1970 - 1973 Corvette: Service Bulletin: Engine Overheat

Model and Year: 1970 - 1973 Corvettes with 454 Cu. In. Engines and Air Conditioning

Source: Chevrolet Dealer Service Technical Bulletin

Bulletin Number: 73-T-28, Section VI

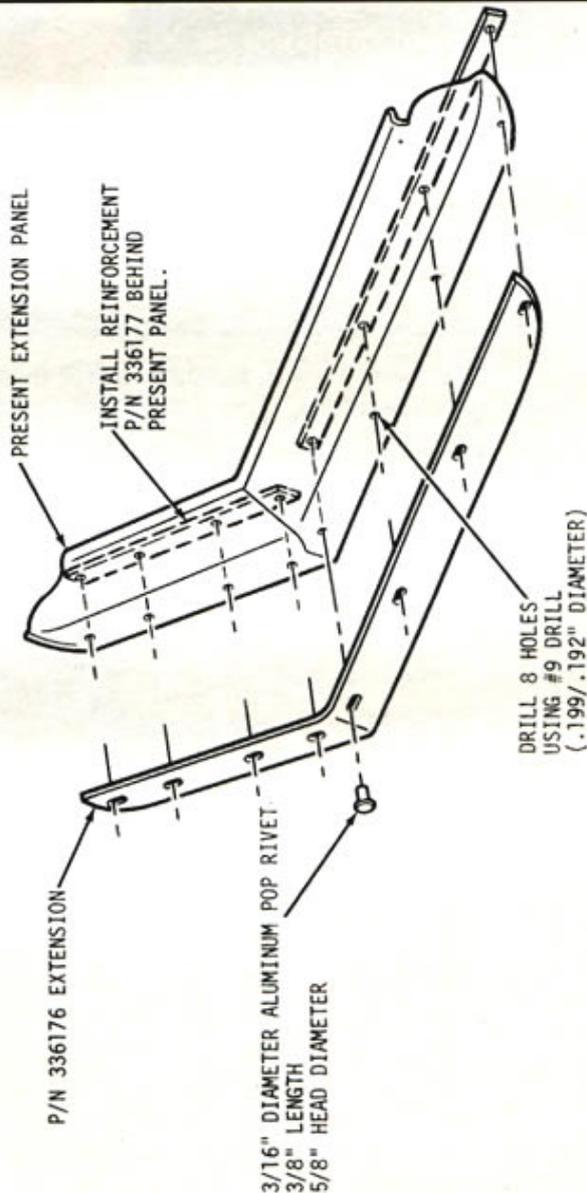
To improve low speed cooling, an additional grille panel lower extension was installed in 1973 Corvettes produced after Vehicle Identification Number 1Z37Z3S410722. This extension, Part Number 336176, may be installed as illustrated on page 2 of this bulletin on early 1973 Corvettes only .
